ENCLOSURE 3 TO TXX-91179
MARKED UP TECHNICAL SPECIFICATIONS
FOR OPERATION OF COMANCHE PEAK UNIT 1
WITH THE CYCLE-SPECIFIC PARAMETERS RELOCATED,
A POSITIVE MODERATOR TEMPERATURE COEFFICIENT, AND
AN FQ SURVEILLANCE

COLR for CPSES UNIT 1 CYCLE 2

FIGURE 3.1-1

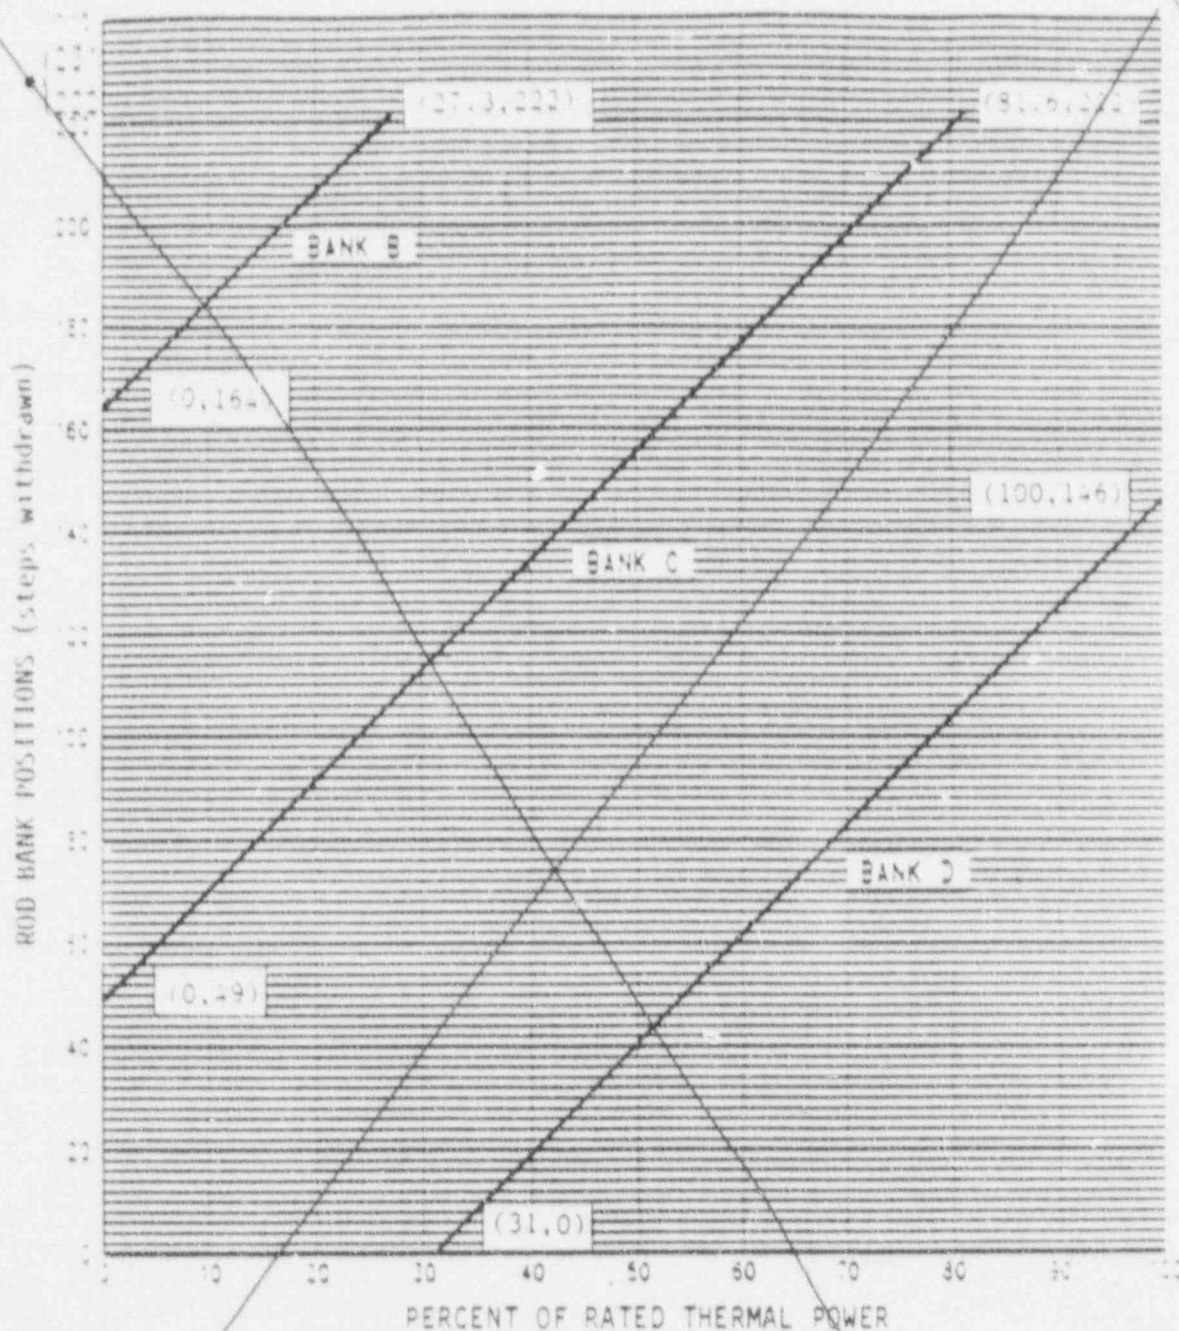
3.1.3.6 The control banks shall be limited in physical insertion as ~~shown in Figure 3-1-1~~ specified in the CORE OPERATING LIMITS REPORT (COLR).

(DELETED)

- 2.3.1 The control rod banks shall be limited physical insertion as shown in Figure 1.

FIGURE 3.2-1

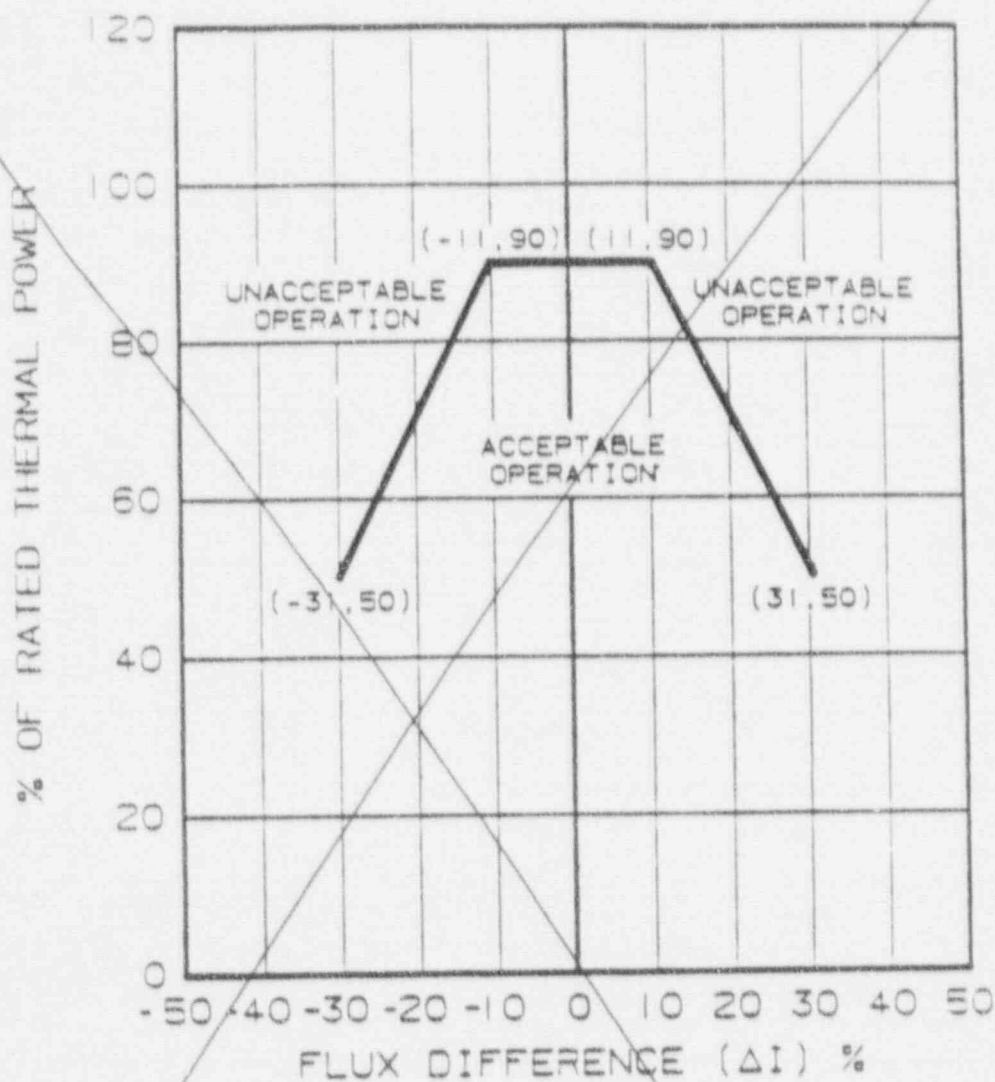
~~For Normal Operation, the indicated AFD may deviate outside the above required target band at greater than or equal to 50% but less than 90% of RATED THERMAL POWER provided the indicated AFD is within the Acceptable Operation Limits of Figure 3.2-1 and the cumulative penalty deviation time does not exceed 1 hour** during the previous 24 hours.~~ *The* *specified in the COLR*

(DELETED)

- 2.4.1 The AXIAL FLUX DIFFERENCE (AFD) target band is +5%, -5%, for core average accumulated burnup \leq 3000 MWD/MTU.
- 2.4.2 The AFD target band is +3%, -12%, for core average accumulated burnup $>$ 3000 MWD/MTU.
- where: MWD/MTU stands for megawatt days/metric tonne of initial uranium metal
- 2.4.3 The AFD Acceptable Operation Limits are provided in Figure 2.

FIGURE 3.2-2

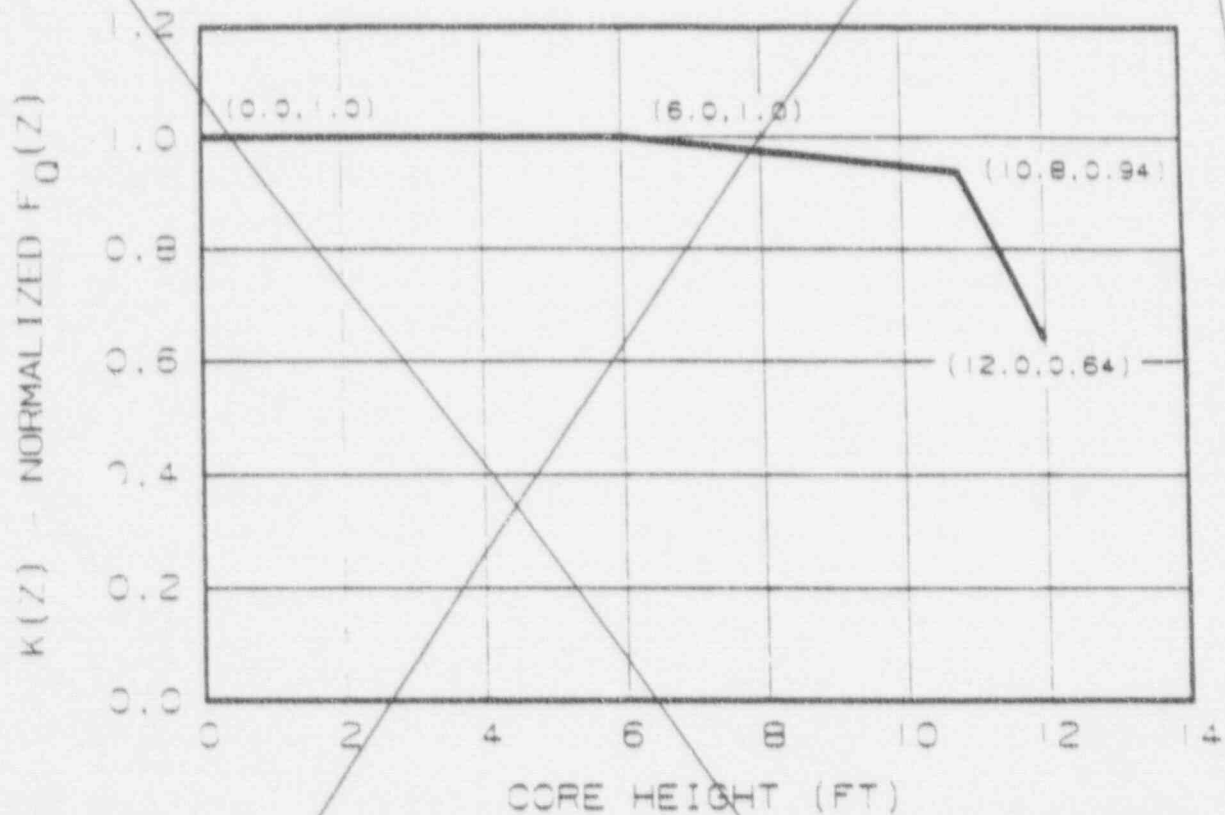
$K(Z)$ = the normalized $F_Q(Z)$ as a function of core height specified in the COLR.

(DELETED)

2.5.2 $K(Z)$ is provided in Figure 3
